Proposal for amendments to document GRSG/2023/11 (Supplement 2 to the Original Version of UN Regulation No. 160 (Event Data Recorder))

The text reproduced below was prepared by the expert from the International Organization of Motor Vehicle Manufacturers (OICA) to adapt the introduction of new verification procedures to the original version of the regulation. The modifications to the current text of the proposal by the IWG on EDR/DSSAD (see document ECE/TRANS/WP.29/GRSG/2023/11) are marked in blue bold for new and blue strikethrough for deleted characters.

Corridor ± 10 Per Cent of the Full Scale Range of the Accelerometer

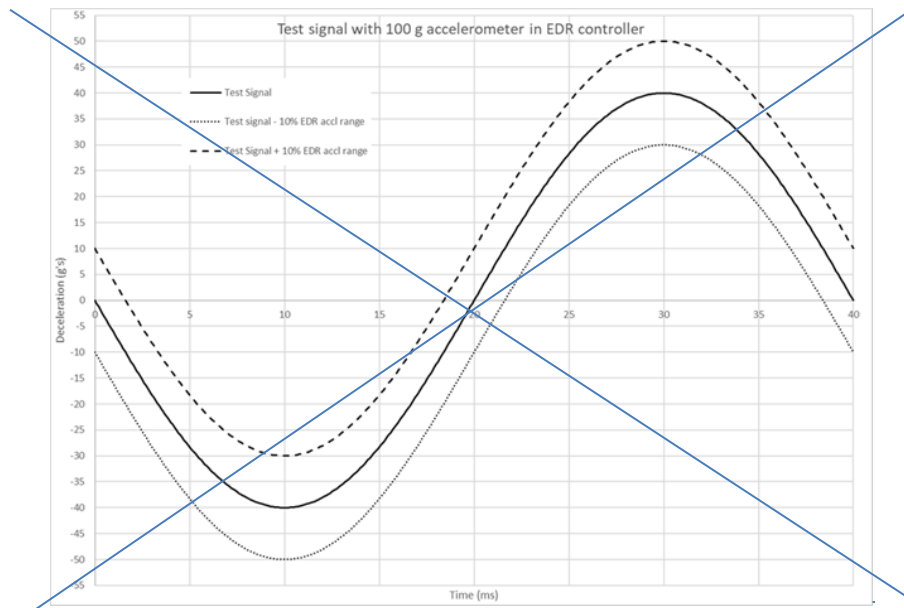
6.1.5. The EDR recorded acceleration trace shall be fully contained in a corridor that is ± 10 per cent of the full-scale range of the accelerometer used by the controller containing the EDR applied to the component test fixture's filtered acceleration trace. The comparison of acceleration sensor traces shall only be made on the axis the component test was conducted.

For example, if the accelerometer in the controller containing the EDR function has a ± 100 g range, then ± 10 g would be applied to the component test fixture's filtered acceleration trace. The EDR recorded acceleration trace shall be fully contained within that corridor (see the Figure).
